UNLESS OTHERWISE SPECIFIED					DRWN	T. HAMERLA	DATE	03-May-2018	FERMI NATIONAL ACCELERATOR LABORATORY UNITED STATES DEPARTMENT OF ENERGY
±.X	±.XX	±.XXX	±X/X	±X"	CHECKED		DATE		
.1	.02	.005	1/16	1"	APPROVED		DATE		
BREAK ALL SHARP EDGES .015 MAX. DO NOT SCALE DRAWING DIMENSIONS BASED ON ASME Y14.5-2009 MAX. ALL MACH SURFACES 125/ DRAWING UNITS: INCHES					DRAWN ON MATERIAL GROUP: Accelerator Mechanical Support CASE CODE: QUR58		NAME ITOA GAS JET PROFILE MONITOR - TEST ASSEMBLY		
SCALE 1:2			SIZE E	DRAWING NUMBER F10101459	SHEET 1 OF 1	REV -

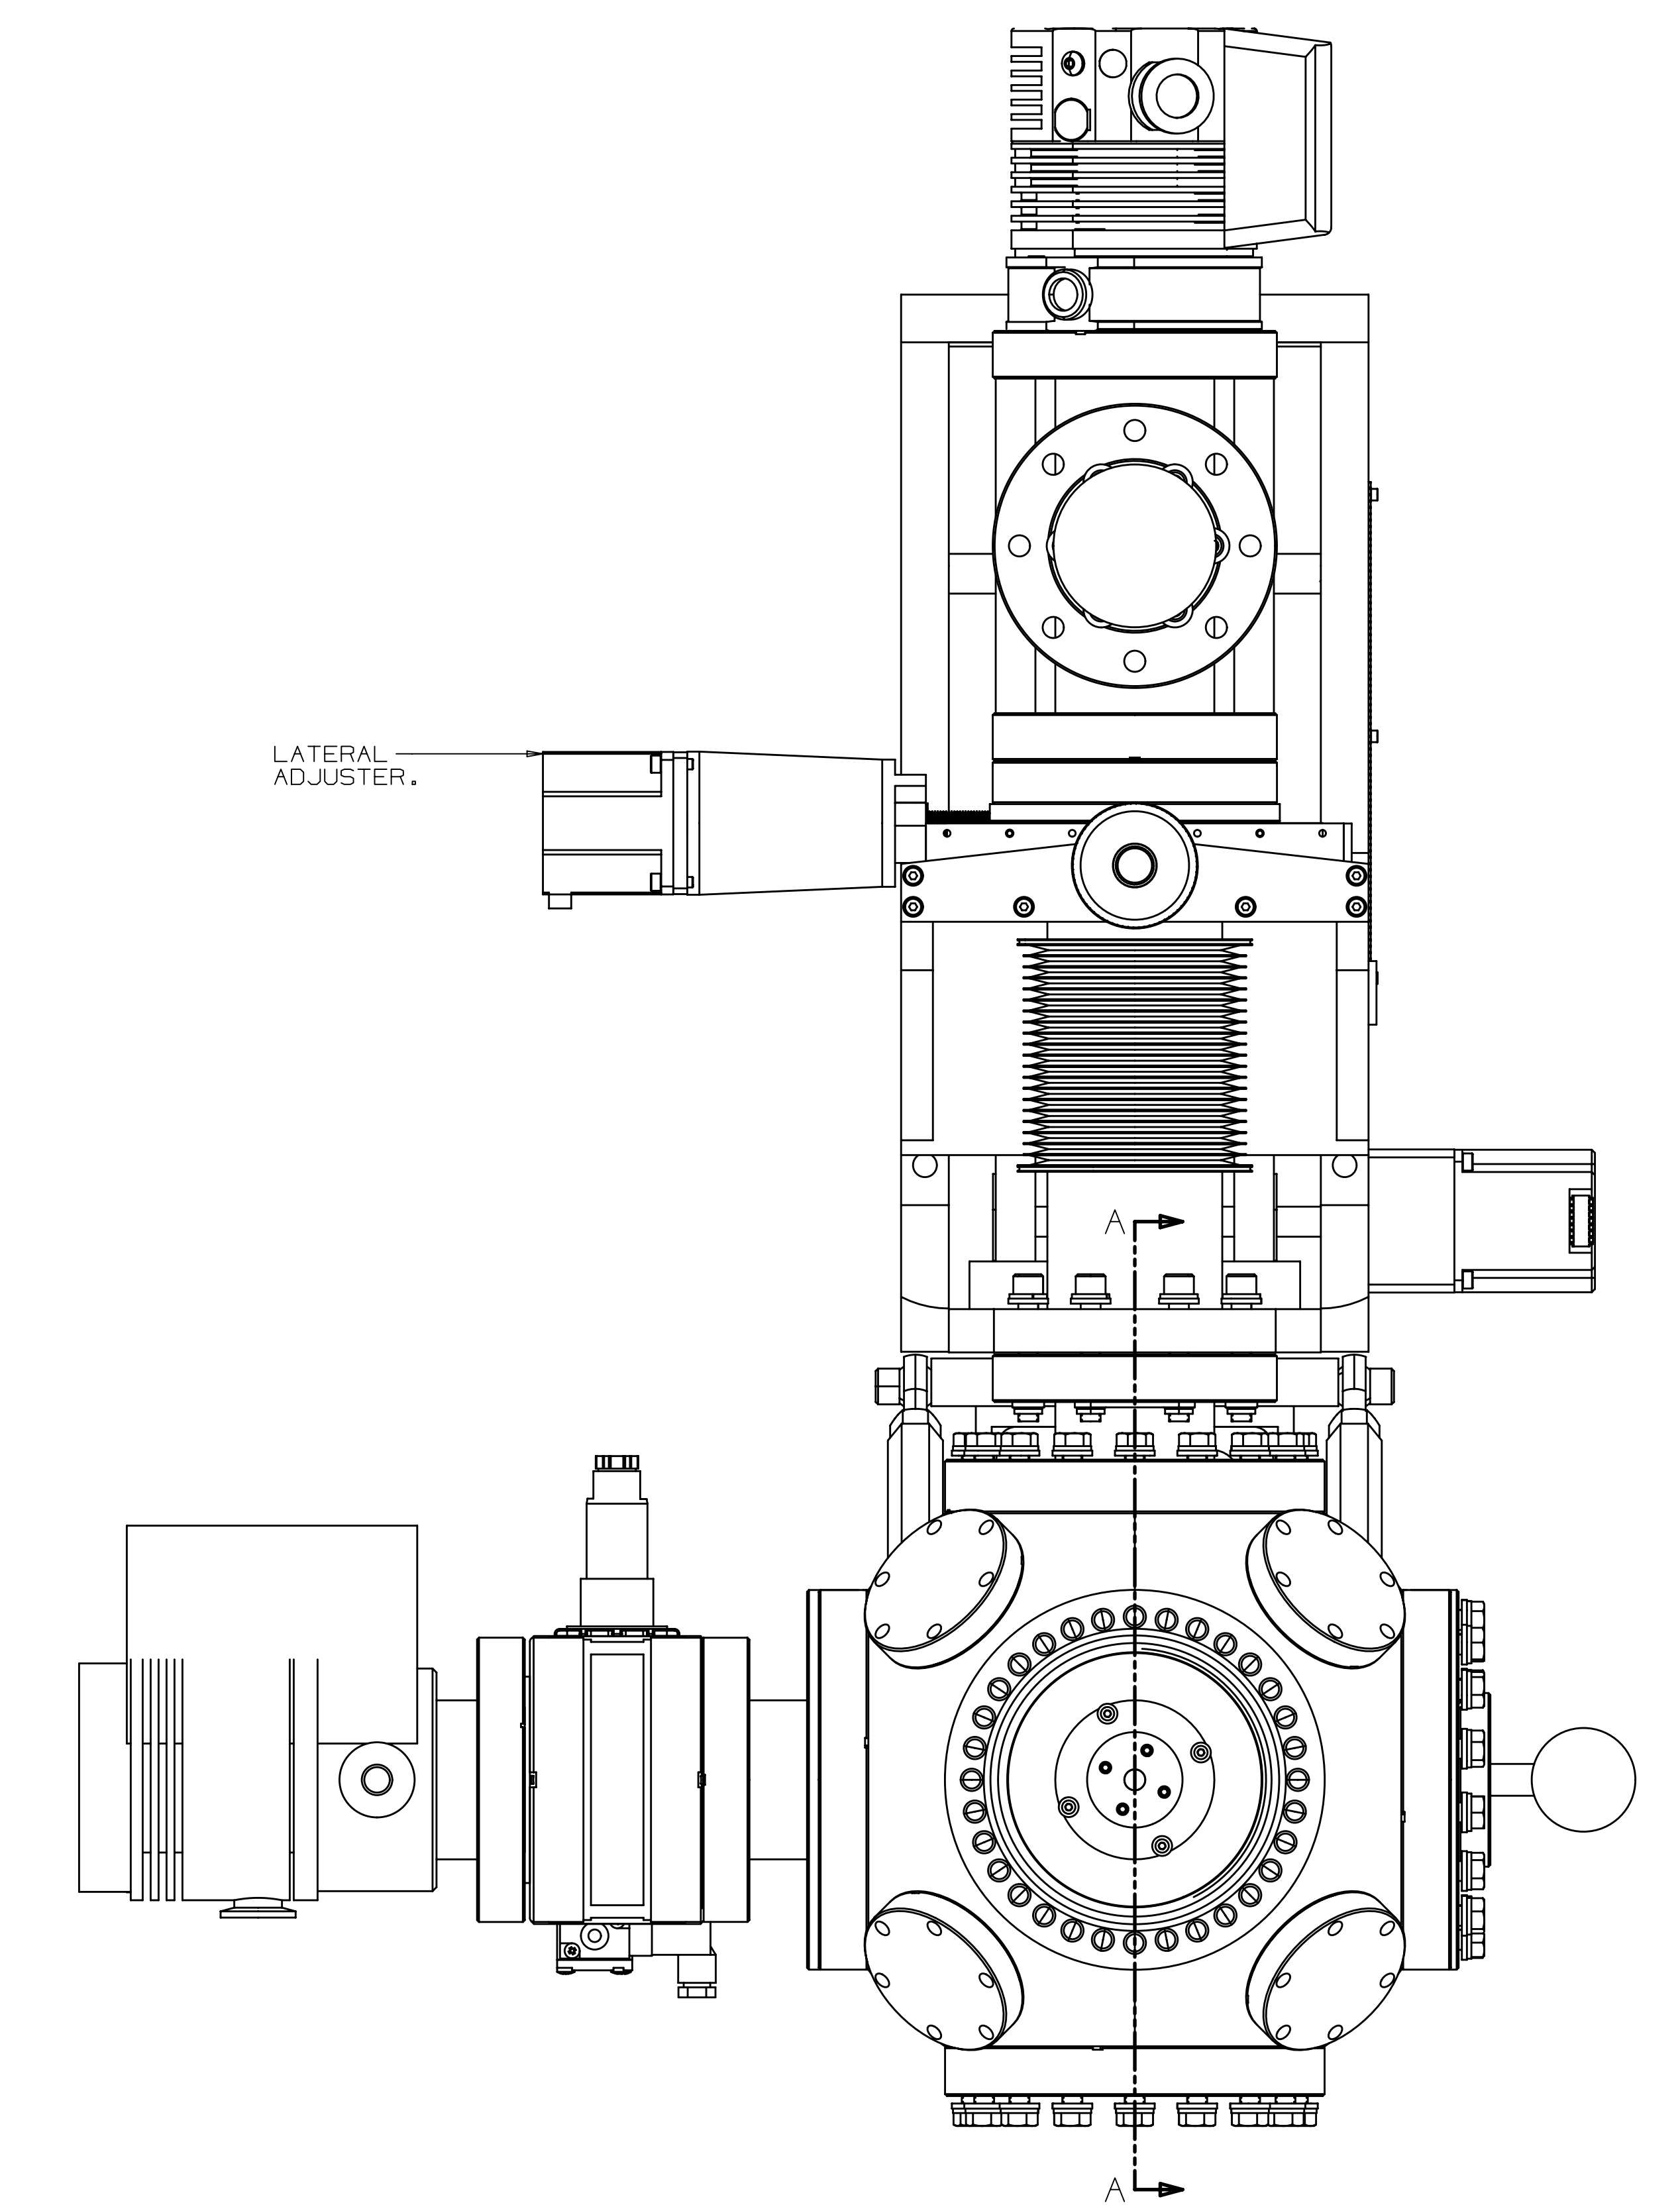
An alignment spider type support about here! It should keep alignment of the two skimmer nozzles to within .010 inches of each other.
